From: Tesfaye, Getachew
Sent: Tuesday, May 04, 2010 7:49 AM
To: Wheeler, Larry; Eul, Ryan; Lee, Samuel; Segala, John; Hearn, Peter; ArevaEPRDCPEm Resource
Subject: FW: DRAFT Responses for FSAR Chapter 9 Weekly NRC Telecon
Attachments: Blank Bkgrd.gif; DRAFTRESPONSE RAI 356 Supp 1 Q.09.02.02-86(a-c).pdf; DRAFTRESPONSE RAI 345 Supp 1 Q.09.02.01-34.pdf; DRAFTRESPONSE RAI 345 Supp 1 Q.09.02.01-41 (b-d).pdf; DRAFTRESPONSE RAI 345 Supp 1 Q.09.02.01-44.pdf

Request for Additional Information No. 356 (4232), Revision 0

U. S. EPR Standard Design Certification
AREVA NP Inc.
Docket No. 52-020
SRP Section: 09.02.02 - Reactor Auxiliary Cooling Water Systems
Application Section: 09.02.08

09.02.02-86

Figure 9.2.8-1—Safety Chilled Water System Diagram
Sheet 1 of 4

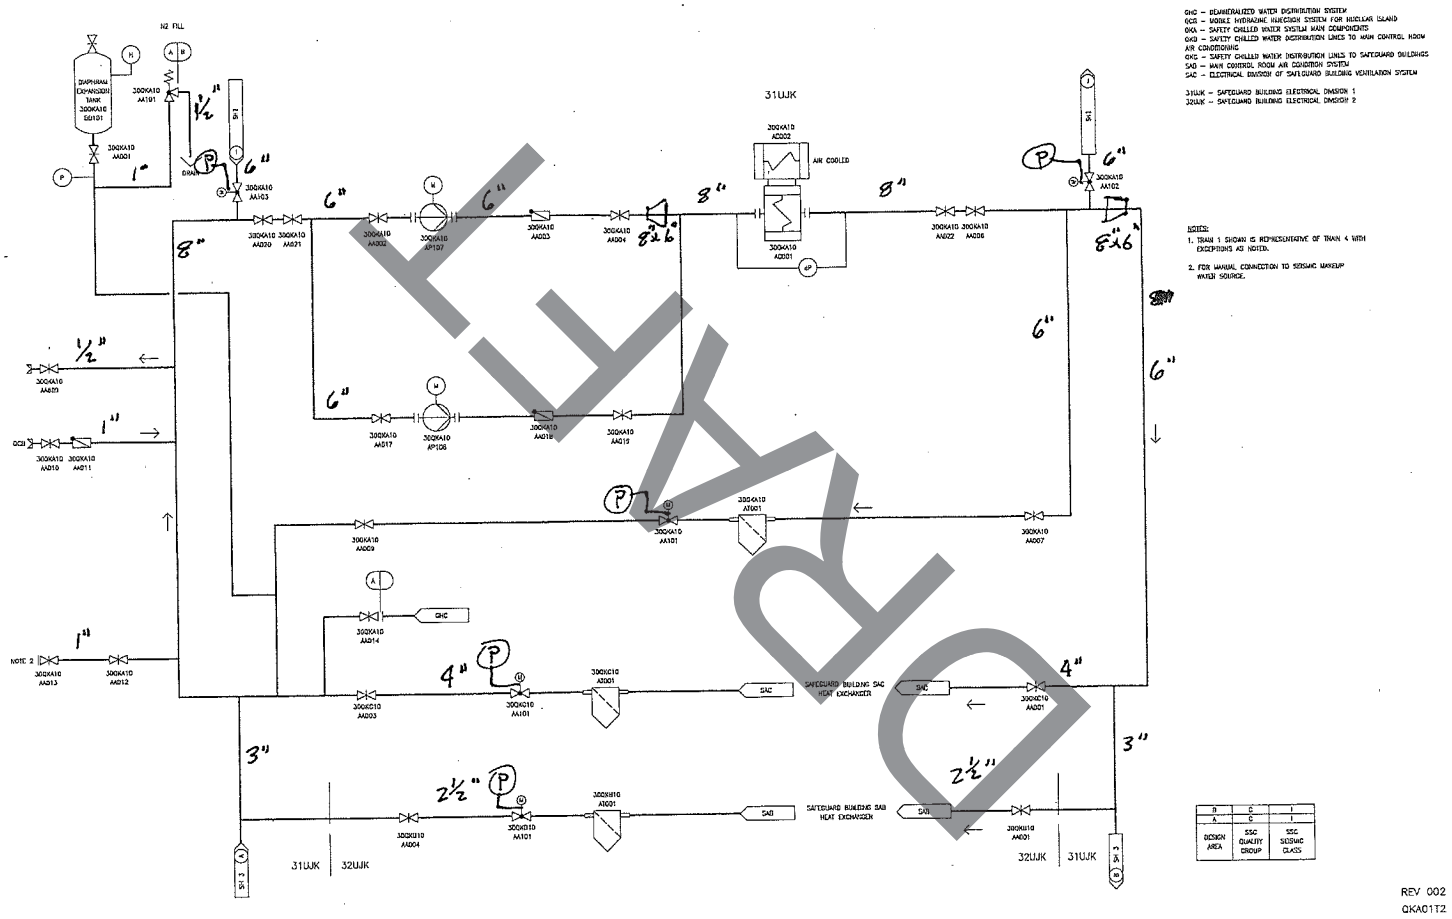
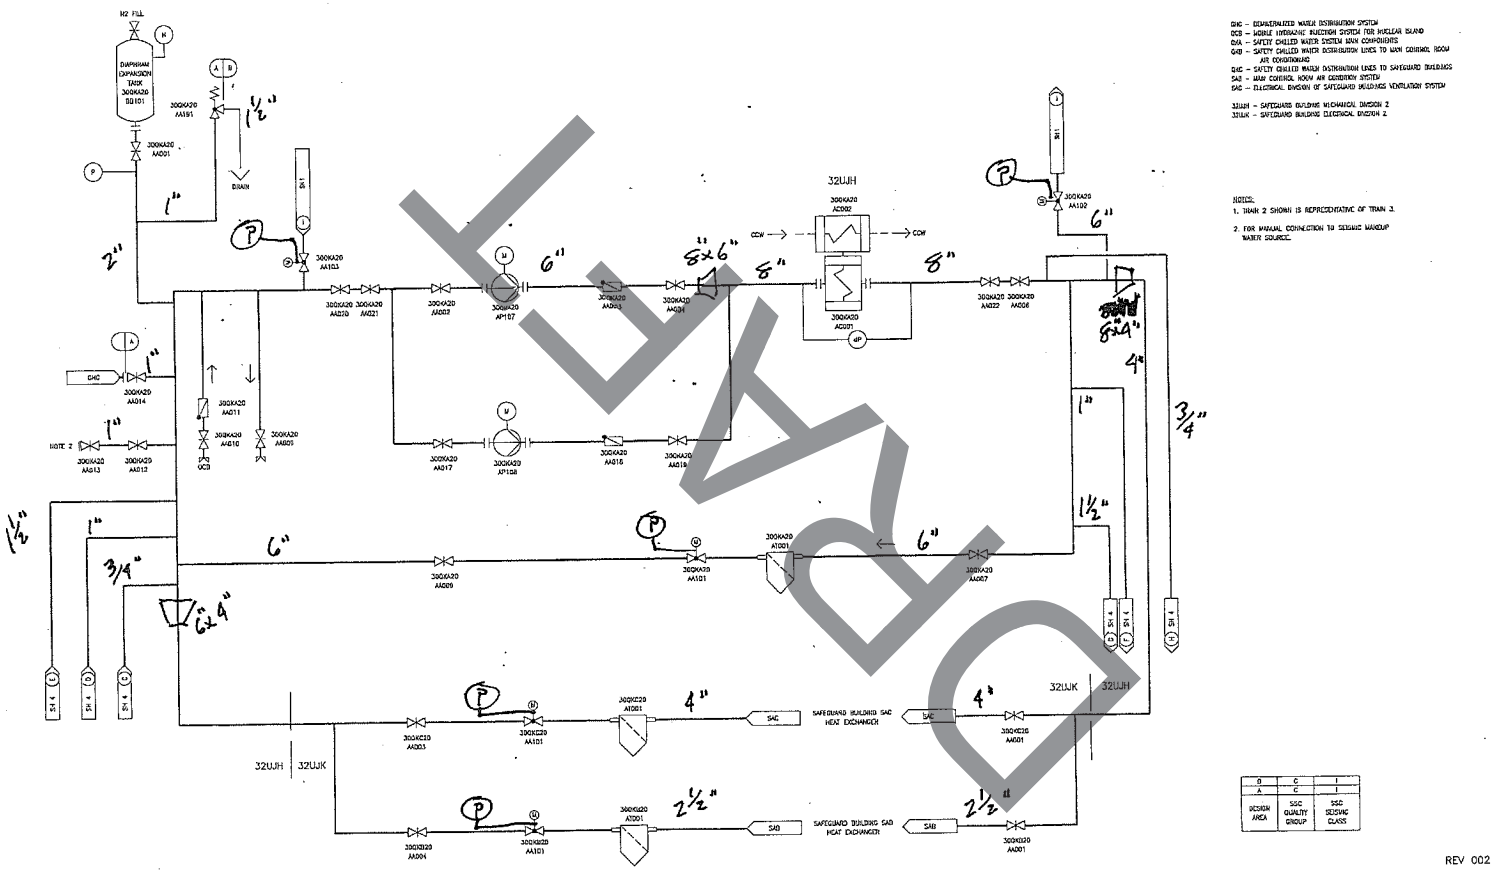
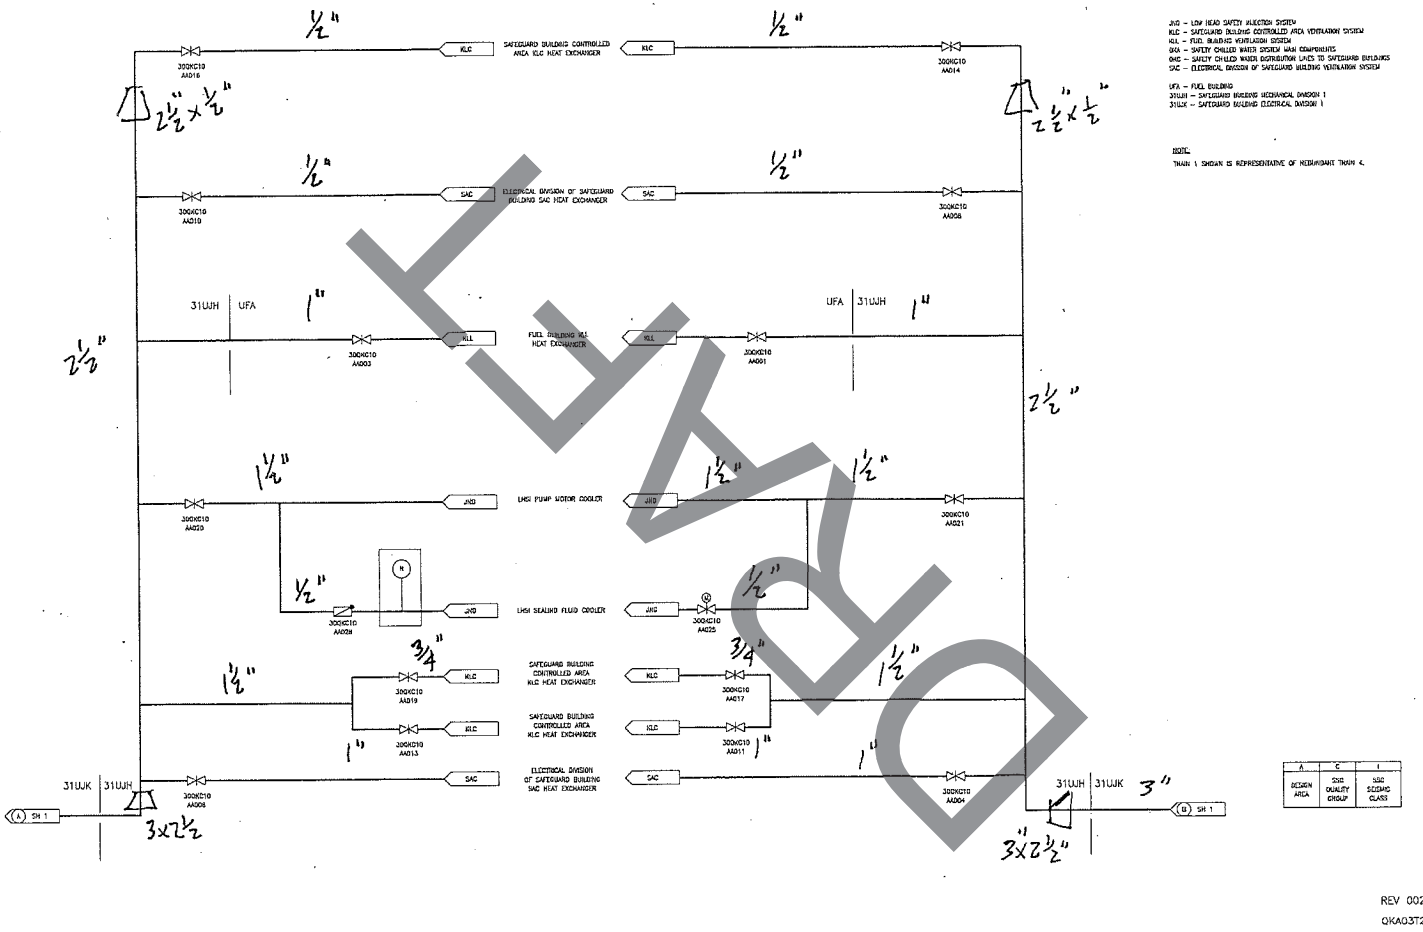
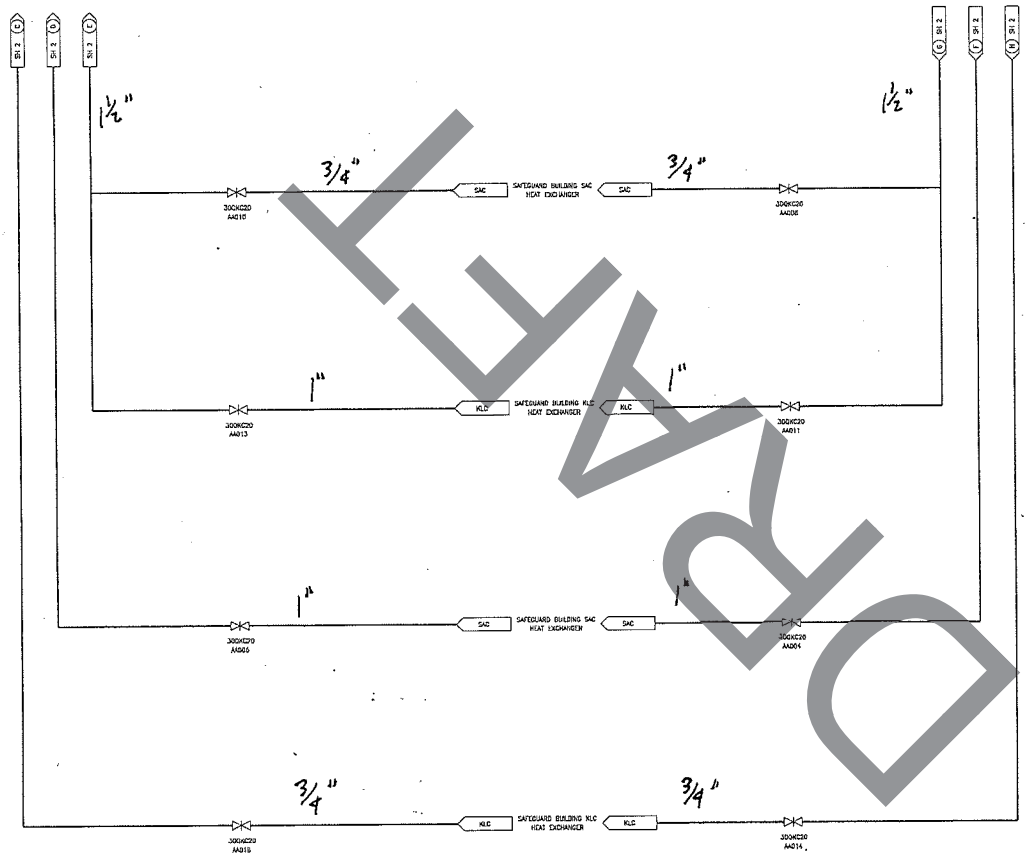
a. Pipe sizes are not shown on the Tier 2, FSAR Figure 9.2.8-1, and the system description does not explain the criteria that were used in establishing the appropriate bounding pipe sizes (such as limiting flow velocities from conceptual/preliminary design studies).

c. Tier 2, FSAR Figure 9.2.8-1 does not show the location of the indications display (e.g., local, remote panel, control room), and does not identify the instruments that provide input to a process computer and/or have alarm and automatic actuation functions.

d. Tier 2, FSAR Figure 9.2.8-1 does not identify the normal valve positions, the valves that are locked in position, and the valves that have automatic functions. These design features should be described.

e. Tier 2, FSAR Figure 9.2.8-1 does not show specific set point for system alarms (including head tank) and relief and the bases for these set points are not explained in the system description.

f. Isolation valves for taking components out of service for maintenance are not shown on the Tier 2, FSAR Figure 9.2.8-1.
g. Describe in Section 9.2.8 showing the filters in the return lines for some but not all HVAC units.

a. Pipe sizes will be added to Tier 2, FSAR Figure 9.2.8-1. Tier 2 FSAR section 9.2.8.1 will be revised to explain the criteria that were used in establishing the appropriate bounding pipe sizes.
b. System operating temperatures, pressures, and flow rates for cross-tie and single division operation will be provided in revised Tier 2, FSAR Table 9.2.8-1 and added Table 9.2.8-2.
c. Location of the indications display, input to a process computer and/or alarm and automatic actuation functions, for instruments on Tier 2, FSAR Figure 9.2.8-1 will be provided in Tier 2, FSAR Table 9.2.8-3

Figure 9.2.5-3 Cross Section of UHS Tower Basin Schematic

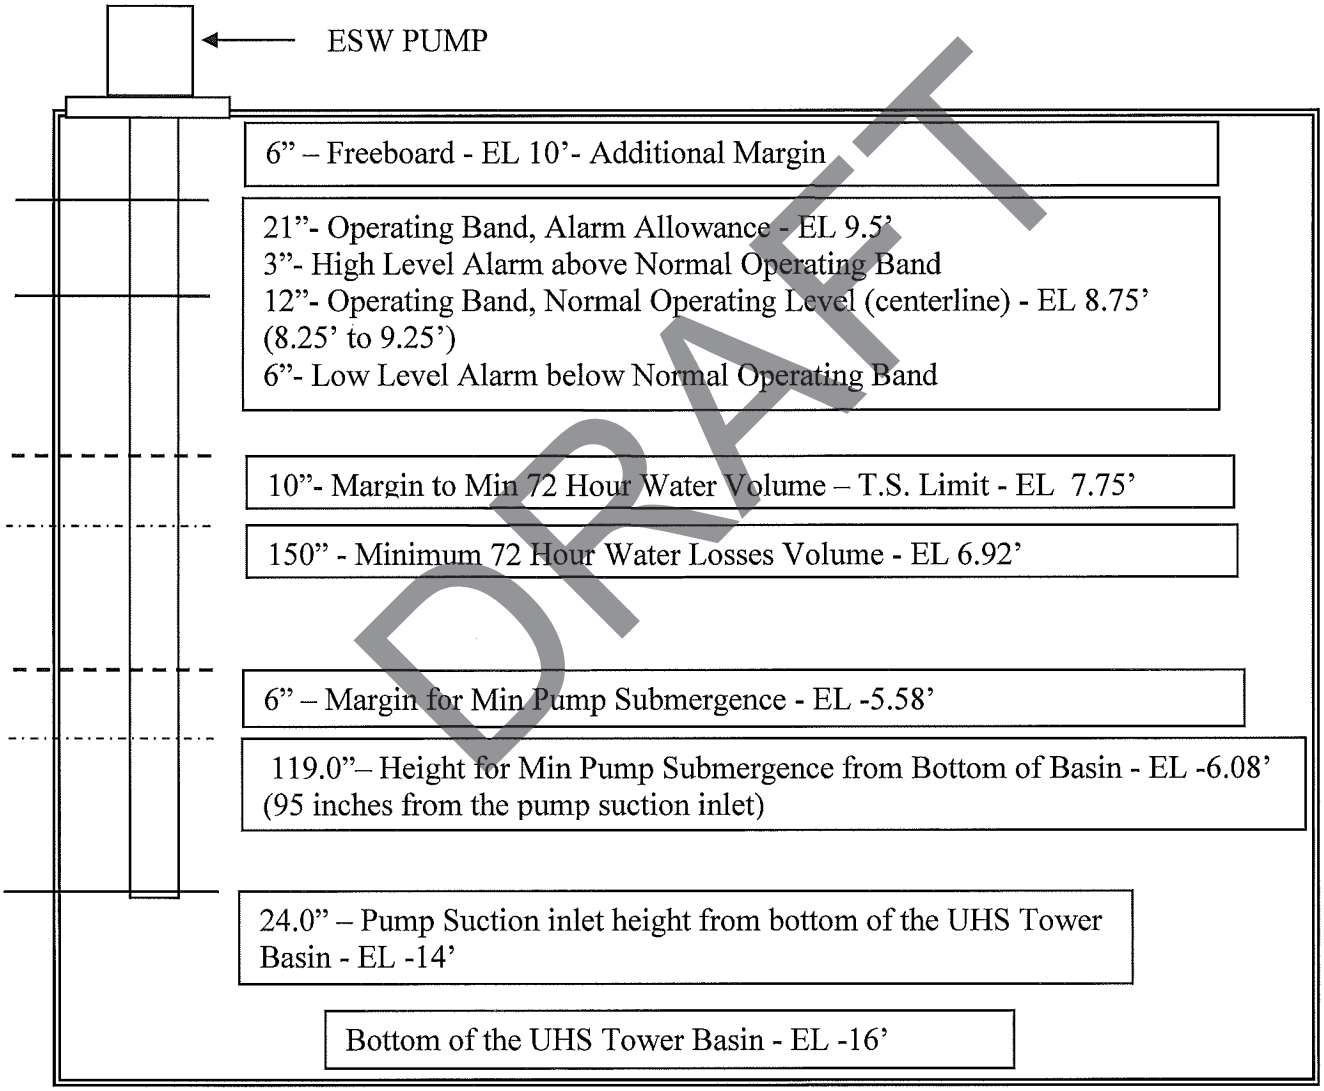
b. Provide an explanation or clarification of the basin water level at which the ESWS pumps will still be able to perform their intended safety related function since it appears based on Figure 09.02.01-17-1 that at elevation 6.92' (minimum 72 hours water losses volume), the ESWS pumps remain operable at this level. Add to the table NPSH and vortex water level elevation from RAI 9.2.1-08.

d. The applicant should consider providing Figure 09-02-01-17-1 as a DCD figure since this is an important part of the licensing basis of the ESW pumps defining margins related to NPSH and vortexing, alarms, operating bands, related to the UHS basin.

After 72 hours post accident, the basin water level will be no lower than elevation -5.58' with 6" margin to the minimum pump submergence elevation -6.08'. The ESWS pumps will be able to perform their intended safety related function and remain operable at this elevation. Additionally, a 10" basin level margin is provided above the minimum 72 hour water losses volume at elevation 6.92'.

The figure provided in Response to RAI 119, Question 09.02.01-17 (Figure 09.02.01-17-1) will be provided in the U.S EPR FSAR as Tier 2, Figure 9.2.5-3. In order to completely define basin water level, the distance between the pump suction inlet and the bottom of the basin (24") will also be clearly identified.
